MFN 10-089 Revision 1

Subject: **Revised Response to NRC RAI Letter No. 409 Related to ESBWR Design Certification Application – DCD Tier 2 Section 10.2 – Steam and Power Conversion System; RAI Number 10.2-18 S03**

DCD Tier 2 Section 10.2 – Steam and Power Conversion System

RAI Number 10.2-18 S03

Figure 2.11.1-2. High Pressure Turbine Exhaust Functional Arrangement

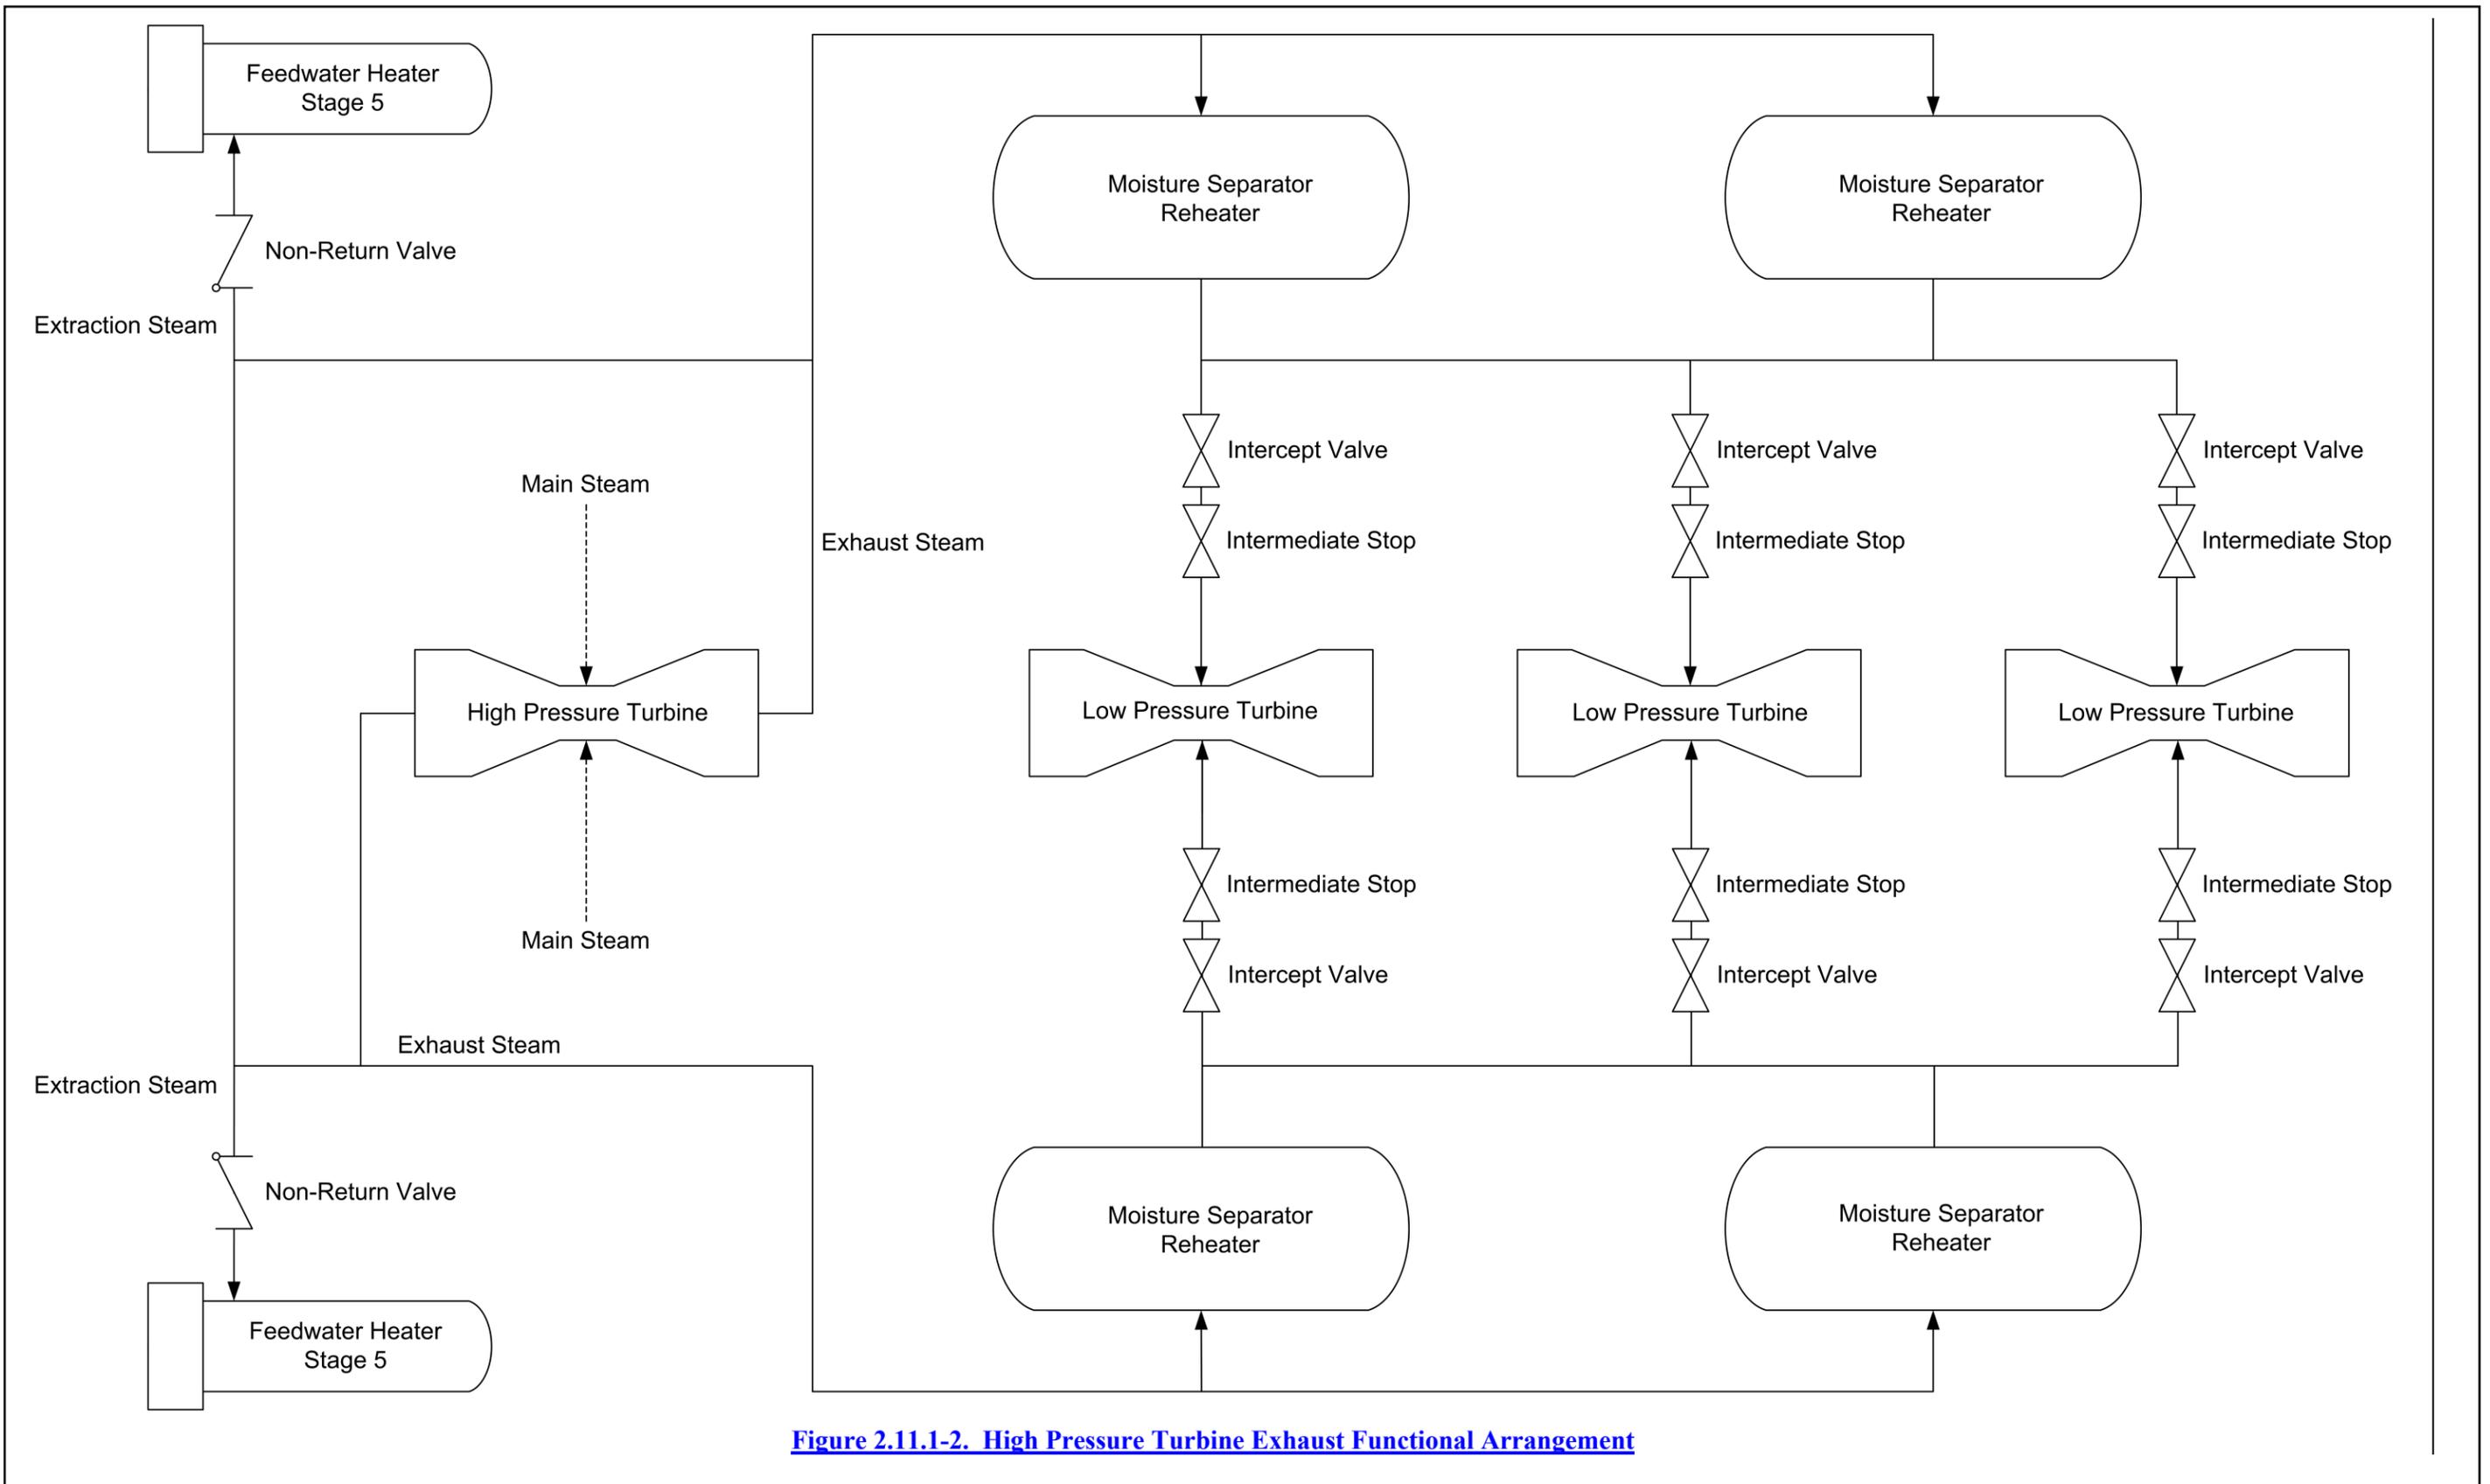
12) An ITAAC is needed to verify the layout/locations of turbine stop, control, intermediate stop, intercept, and extraction non-return valves.

DCD Tier 1 Subsection 2.11.1 covers the proposed DCD Tier 1 design description, Table 2.11.1-1 and Figure 2.11.1-1, -2, and -3 diagrams that verify the layout/locations of turbine stop, control, intermediate stop, intercept, and spring assisted extraction non-return valves. The DCD Figure 2.11.1-2 has the exhaust steam and extraction steam lines labeled to preclude confusion on location. Simple check type non-return valves installed on extraction lines are not required to be shown in the DCD or Tier 1 since they do not have a function in turbine overspeed protection.

[\(12\) The non-return valves shown on functional arrangement Figure 2.11.1-2 and 2.11.1-3 are spring assisted to close.](#)
